SHOP DRAWING TRANSMITTAL

Project: Turnbull School Music Room Addition Project No: 1705
Date: November 9, 2018
To: TALCO Building Innovations Ltd.
Attn: Farah Bano (fbano@tal-co.com)
From: Michelle Cataldo

Shop Drawing Submittal: Division 23 – RTU, Curb, & Vibration Rail
Submitted by: Ventilation S.M. Inc.
Drawing Title: RTU Spec Sheet, Curb Spec Sheets, Vibration Rail Spec Sheet
Revision No. N/A
Dated: Oct. 30, 2018

Mech Shop Drawing Review Comments

Consolidated Drawing

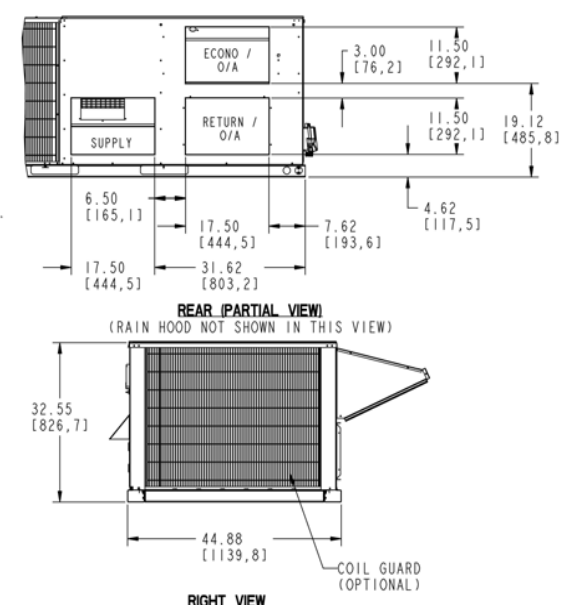
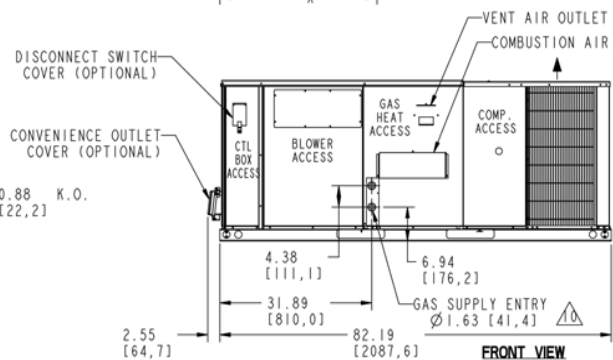
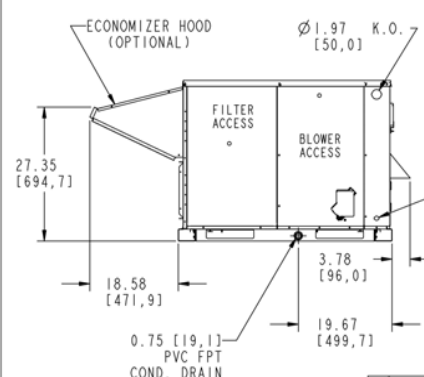
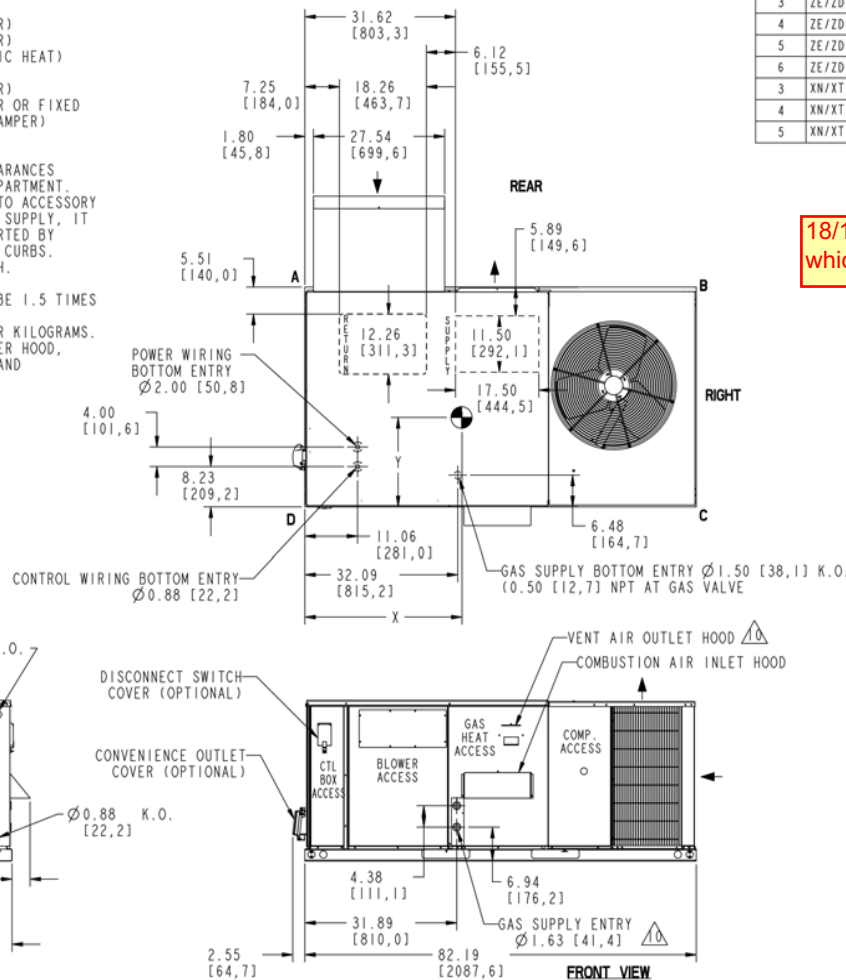
18/11/09 HOBIN: Refer to CCO-007 for ESI-02 which states 30A 208V three pole circuit breaker
